MELFA Technical News

BFP-A6079-0247E

Subject: Notification of Transporting Jig Change**Applicable to: RV-35/50/70F series**

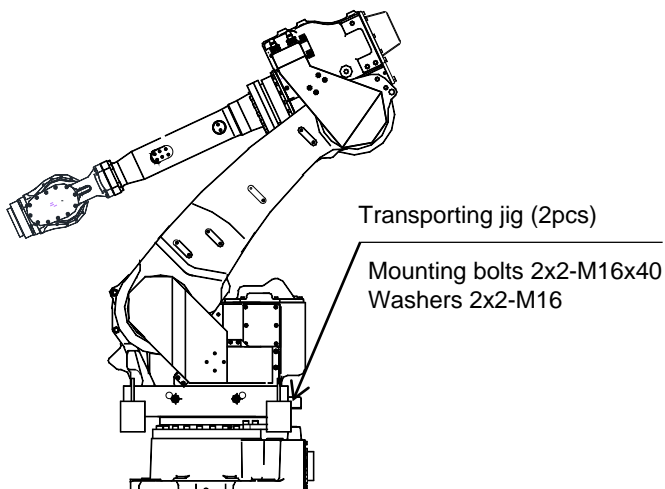
The shape of transporting jig bracket and its thickness are changed. Due to this change, the length of the mounting bolts becomes longer and washers are added.

As the location of the mounting holes are not changed, there is no impact on robot itself nor packaging.
